To: Planning Committee
From: Wayne Craig
Director, Development

Date: March 9, 2022
File: RZ 18-829337

Re: Application by Zhao XD Architect Ltd. for Rezoning at 8031, 8051, 8071 No. 2 Road and 5760, 5780, 5786 Blundell Road from the “Single Detached (RS1/E)” Zone to the “Medium Density Townhouses (RTM3)” Zone

DRAWING TITLE:
TREE MANAGEMENT PLAN

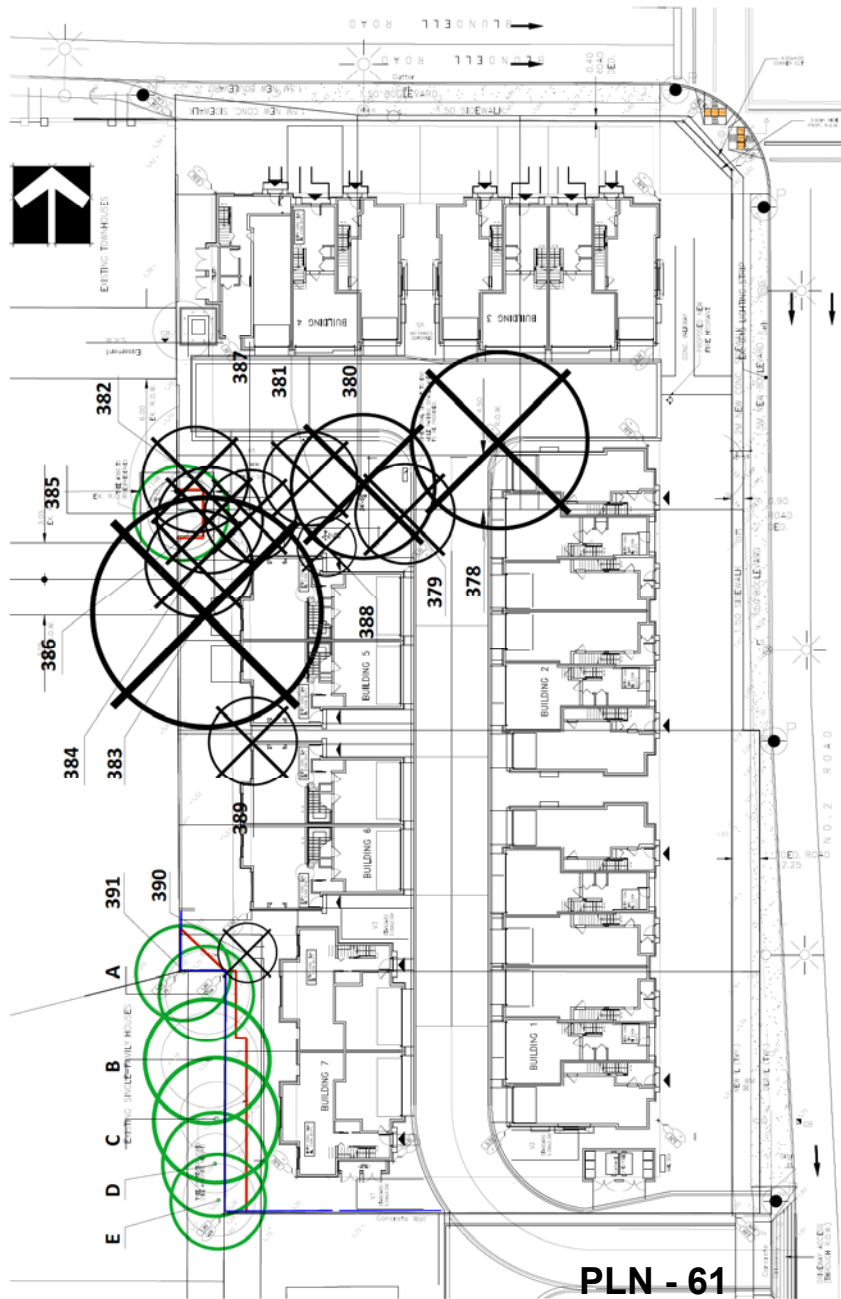
- One tree (Tag # 385 – 25 cm cal Cherry) located in the proposed outdoor amenity area is in good condition and is proposed to be retained. Design development to provide a minimum 1.5 m tree protection zone out from the base of the tree. A \$5,000.00 Tree Survival Security is required for this tree.

- One tree (Tag # 391 – multi-stem Hazelnut) located on a shared property line with the neighbour to the west is in good condition. Provide a minimum 2.1 m tree protection zone out from the base of the tree. A \$5,000.00 Tree Survival Security is required for this tree.

- One tree (Tag # 378 – 92 cm cal Black Locust) located on-site is in moderate condition and is considered a significant tree. This tree is considered an invasive species, and as a result should be removed and replaced with three trees.

- One tree (Tag # 380 – 44 cm cal Black Locust) located on-site is in good condition. This tree is considered an invasive species, and as a result should be removed and replaced.

- One tree (Tag # 383 – 120 cm cal White Poplar) located on-site is in poor condition and is considered a significant tree. This tree is at risk of failure, and as a result should be removed and replaced with three trees.

- Four trees (Tag # 381, 382, 388, 390) located on-site are identified in poor condition; either dead, dying, sparse canopy foliage, have been previously topped or exhibit structural defects such as cavities at the main branch union and co-dominant stems with inclusions. As a result, these trees are not good candidates for retention and should be removed and replaced.

- Five trees (Tag # 379, 384, 386, 387, 389) located on-site are in moderate condition and generally shrub-like in form with limited landscape value. These trees are proposed to be removed due to conflicts with Building 5 and the proposed shared outdoor amenity area. Remove and replace.
- Five trees (Tag # A, B, C, D, E) located on neighbouring property at 8080 Cantley Road are to be protected as per project Arborist Report recommendations.
- Two hedges in the No. 2 Road frontage are in conflict with the required sidewalk upgrades and are proposed to be removed. No compensation is required for hedges.
- One hedge located on the property line between 8031 and 8051 No. 2 Road is in conflict with Building 2 and is proposed to be removed. No compensation is required for hedges.
- Replacement trees should be specified at 2:1 ratio as per the OCP.

Two on-site trees (Tag # 385, 391) and five trees on neighbouring properties (Tag # A, B, C, D, E) are to be retained and protected. The applicant has submitted a tree protection plan showing the trees to be retained and the measures taken to protect them during development stage (Attachment 7). To ensure that the trees identified for retention are protected at development stage, the applicant is required to complete the following items:
